FSN Ref: MRBR- MRBR-26H022

FSCA Ref: MRBR-26H021

Date: 28.01:2026

Urgent Field Safety Notice
Digital Angiography System Trinias

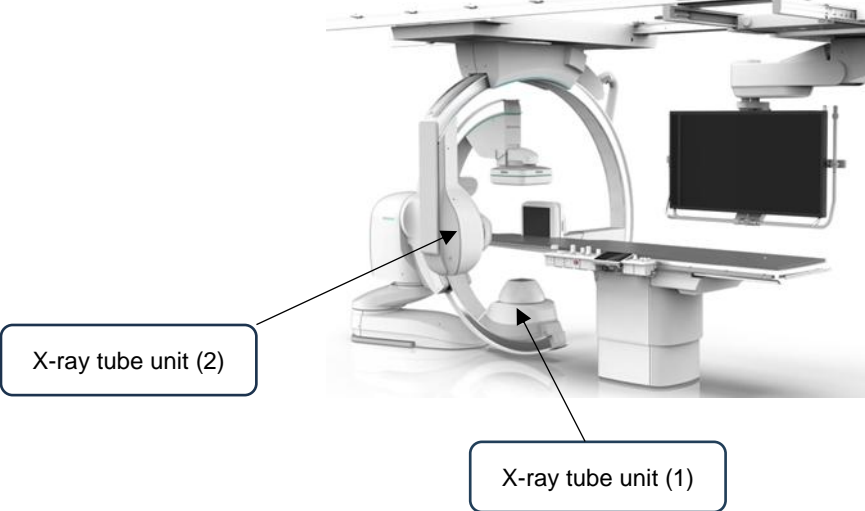
2 Reason for Field Safety Corrective Action (FSCA)*	
2	1. Description of the product problem*
.	In the biplane type (refer the figure below) of the Digital Angiographic System Trinias, when a specific operation is performed, a problem occurs rarely in which X-rays are emitted by the X-ray tube unit (2) even though the X-ray tube unit (1) is selected.

3. Type of Action to mitigate the risk*			
3.	<p>1. Action To Be Taken by the User*</p> <p> <input checked="" type="checkbox"/> Identify Device <input type="checkbox"/> Quarantine Device <input type="checkbox"/> Return Device <input type="checkbox"/> Destroy Device <input type="checkbox"/> On-site device modification/inspection <input type="checkbox"/> Follow patient management recommendations <input type="checkbox"/> Take note of amendment/reinforcement of Instructions For Use (IFU) <input checked="" type="checkbox"/> Other <input type="checkbox"/> None </p> <p>• This issue occurs when switching from a bi-plane to a single-plane during fluoroscopy. Until countermeasures are completed, Please avoid this issue by switching planes after fluoroscopy.</p>

4. Is customer Reply Required? * (If yes, form attached specifying deadline for return)	Yes		
3.	<p>5. Action Being Taken by the Manufacturer</p> <p> <input type="checkbox"/> Product Removal <input checked="" type="checkbox"/> On-site device modification/inspection <input type="checkbox"/> Software upgrade <input type="checkbox"/> IFU or labelling change <input type="checkbox"/> Other <input type="checkbox"/> None </p> <p>We will update the software for the target device so that the X-ray tube unit can be switched correctly.</p>
